Access Compliance Report

Public Rights-of-Way

Intersection ID: 11266	Main Street: AXAR_RD	Cross Street: MULBERRY_CHURCH_RD	Location: SW
ADA ID: E4B8C4C9BF9C	Ramp Type: Perp	Initial Pass/Fail: Fail	Overall Compliance: No
			Severity Score: 21.25

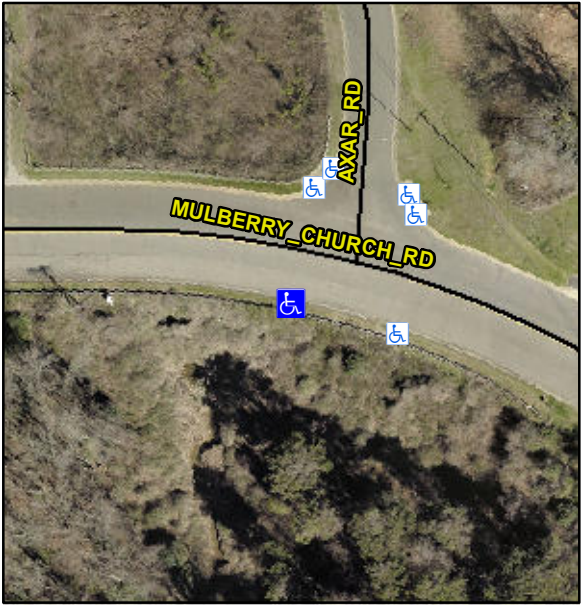
Codes/Mitigation Info/Possible Solution			Field Measurements/Component Compliance		
	Possible Solutions:		Compliance	Description	Data
	Remove & Replace Entire Ramp.		N/A	Ramp Length (in)	66.0
			No	Ramp Width (in)	36.0
			N/A	Flare Type LT	N/A
			N/A	Flare Slope LT (%)	N/A
			N/A	Flare Traversable LT?	N/A
			N/A	Landing Length (in)	N/A
			N/A	Landing Width (in)	N/A
			N/A	Landing Slope (%)	N/A
			N/A	Landing X Slope (%)	N/A
<p>Surveyor Notes:</p> <p>N/A</p> <p>PROW/ADA:</p> <p>Not Found, R304.5.1, R304.2.2</p>			N/A	Flare Type RT	N/A
			N/A	Flare Slope RT (%)	N/A
			N/A	Flare Traversable RT?	N/A
			N/A	DWS Provided?	N/A
			N/A	DWS Contrast?	N/A
			N/A	DWS Length (in)	N/A
			N/A	DWS Full Width?	N/A
			N/A	DWS Offset (in)	N/A
			N/A	Gutter Ponding?	N/A
			N/A	Gutter Lip Ht (in)	N/A
			N/A	Painted X Walk1?	No
				X Walk 1 Direction	To N
			N/A	X Walk 1 Width (in)	N/A
				X Walk 1 Slope (%)	7.3
				X Walk 1 X Slope (%)	1.9

N/A	Ramp inside XWalk1?	N/A
				Road Slope (%)	N/A
				Road X Slope (%)	N/A
			N/A	Any Obstructions?	N/A
				Obstruction Type	
Total Cost:					
		\$ 1850.00			
			N/A		N/A
			Yes	Surface Condition? (G/P)	Good
